# MVCCA Transportation Committee

Update on DCA Aircraft Noise WG

# FAA Proposed Procedural Design Changes

# DCA CLTCH / SCRAM / JDUBB RNAV SIDs (Departures)

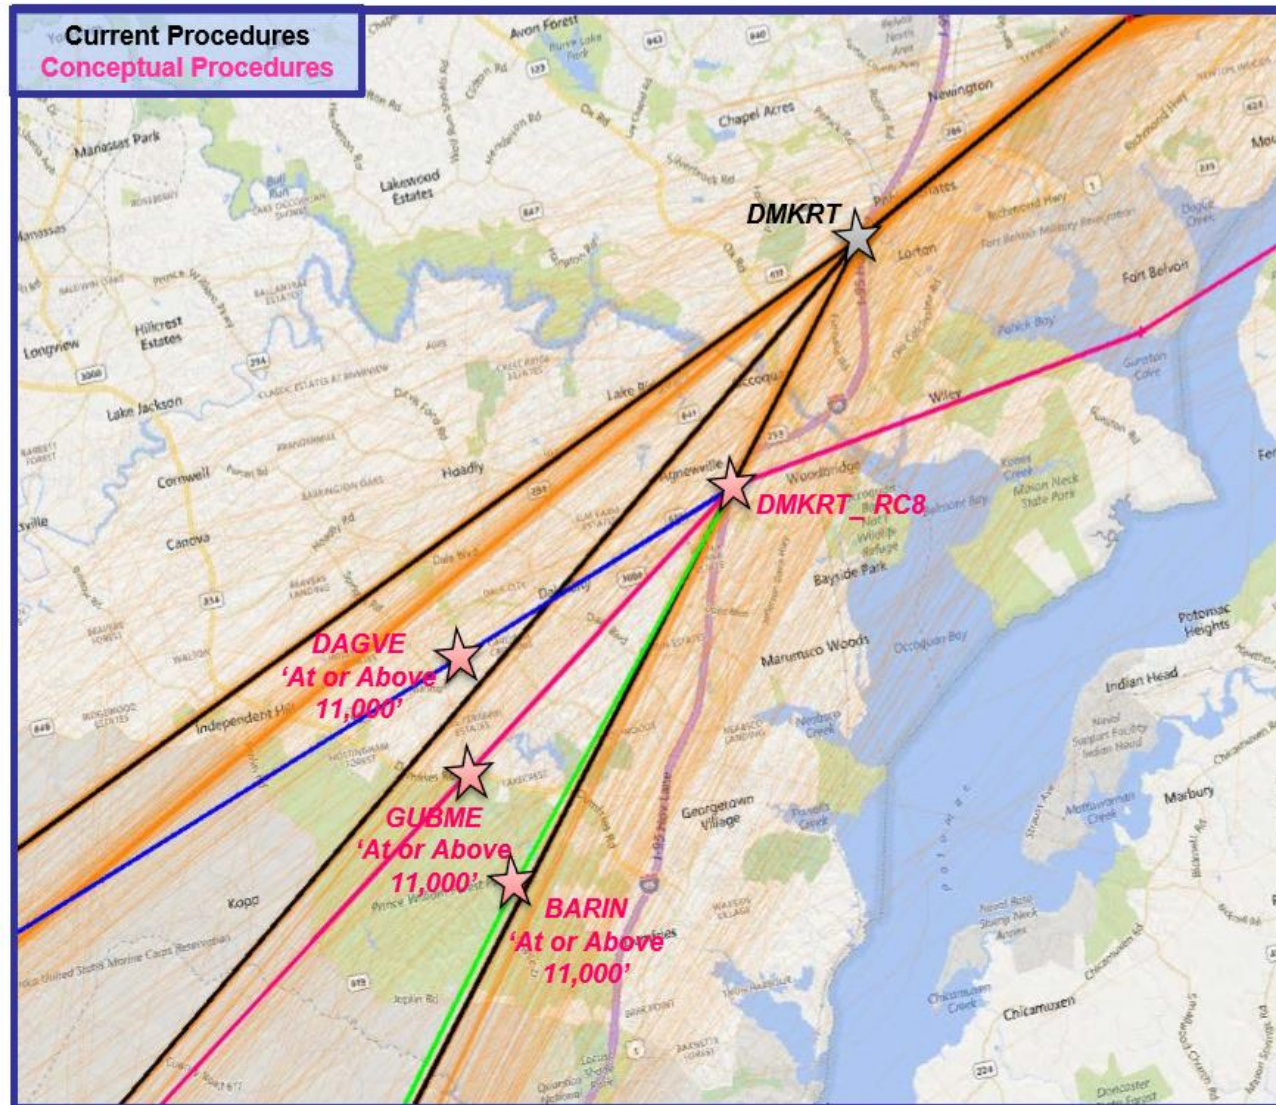
1. Flight tracks would move SE to DMKRT with more flights over MV and PG County – altitude key – how can we ensure airplanes are 5-7K?
2. Altitude at DMKRT RC \* is?
3. Dispersion over MV and PG County
4. Why flight spillover occurs?
5. How will new WP eliminate SO's

- **Per DCA WG Recommendation 8**
  - ✓ To bring departures back over the river added ESSZZ
  - ✓ To remain over the river longer, moved CAPVC 2.71 nm south to CAPVC\_RC8, GAITE 4.18 nm south to GAITE\_RC8, and DMKRT 3.77 nm southwest to DMKRT\_RC8
  - ✓ To clear CAPPS arrivals descending via, added restrictions 'At or Below 5,000'' to CAPVC\_RC8 and 'At or Below 7,000'' to GAITE\_RC8
  - ✓ Estimated altitude at DMKRT\_RC8 – 10,000 feet
- **Current track data (Apr 2017)**

# DCA CAPPS RNAV STAR RWY 19 (Arrival)

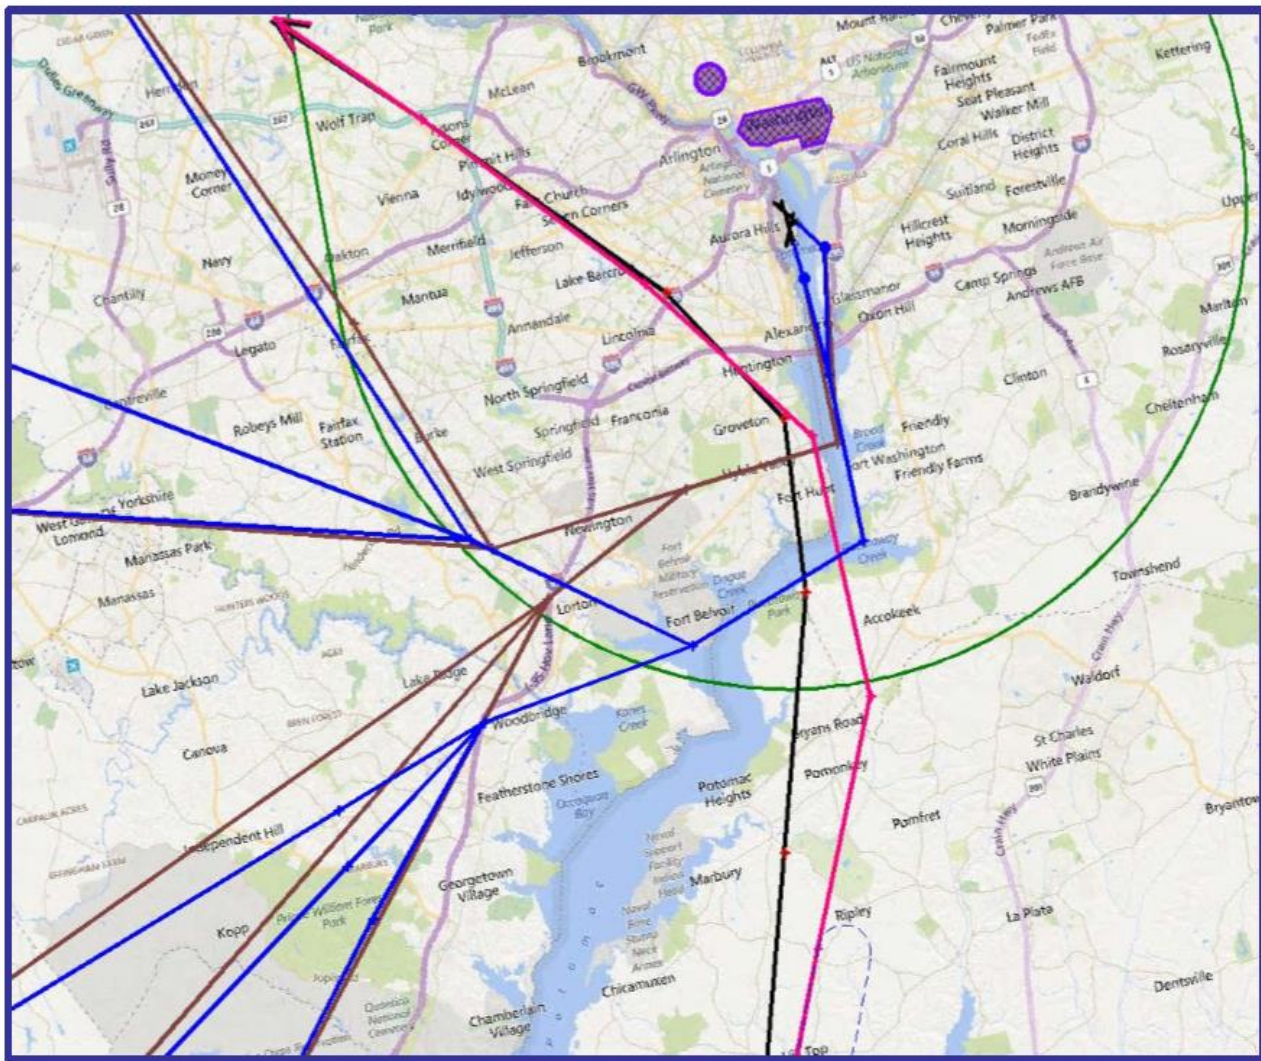
1. Add a new WP between New Giles and New Smoot to keep close to old procedure?
2. Is safety a consideration for adding new track slide 11?

- MOEJO moved 2.71 nm southeast to **NEW\_MOEJO**; 'At 10,000' altitude restriction remains
- JILES moved 3.32 nm southeast to **NEW\_JILES**; altitude restriction added, 'At 9,000'
- SMOOT moved .92 nm southeast to **NEW\_SMOOT**; altitude restriction changed from 'At or Above 7,000' to 'At or Above 8,000'
- BAAAM moved .68 northwest to **NEW\_BAAAM**; 'At 6,000' altitude restriction remains
- **Current track data (Apr 2017)**
